RS-RFQ-007-2023
Request for Quotation
Animal Pound Renovations

Addendum No. 2
(to the Request for Quotation Document)

2. Animal Bath Room

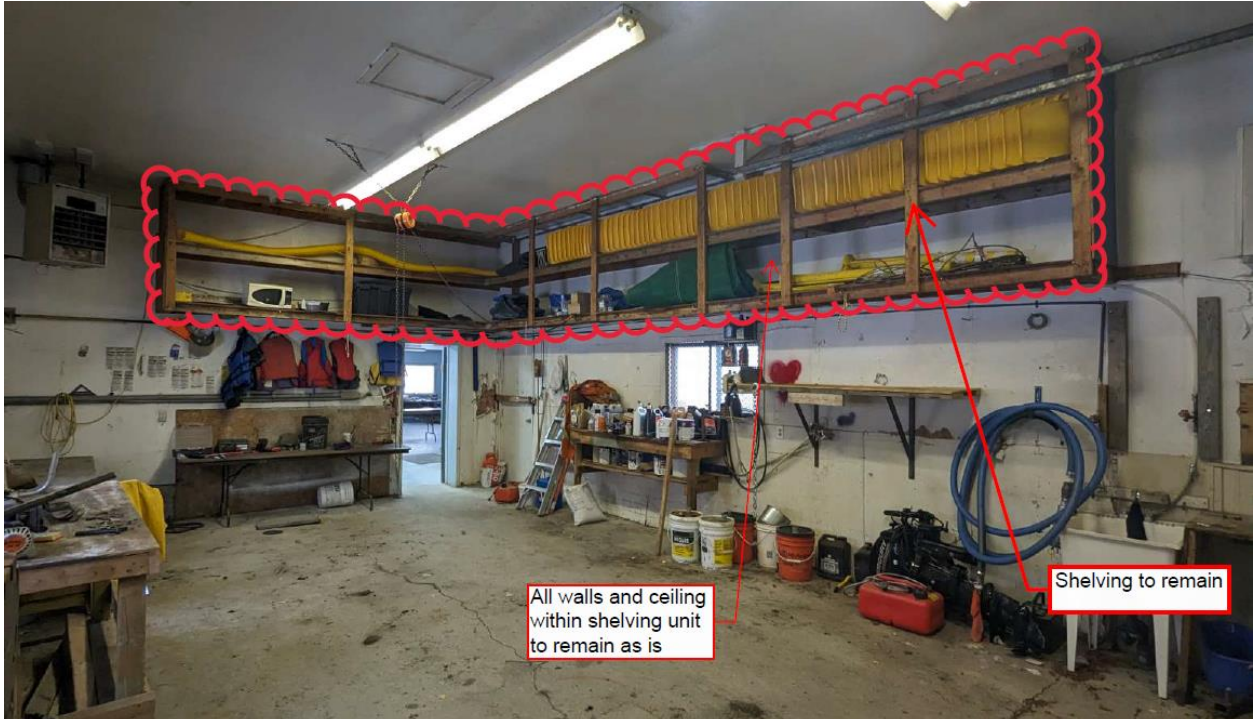
a)	Bidders will be required to relocate the 30" baseboard heater currently in the Animal Bath Room to the opposite wall within the same room. Bidders will also be required to turn a 4" drain cleanout 180 degrees to make it accessible from the adjoining bathroom. The waterline for the toilet within the adjacent bathroom will also need to be moved to accommodate the new shower surround. The new location of the baseboard heater will be the wall between the water heater closet and the Animal Bath Room as indicated on the image below:
-----------	--
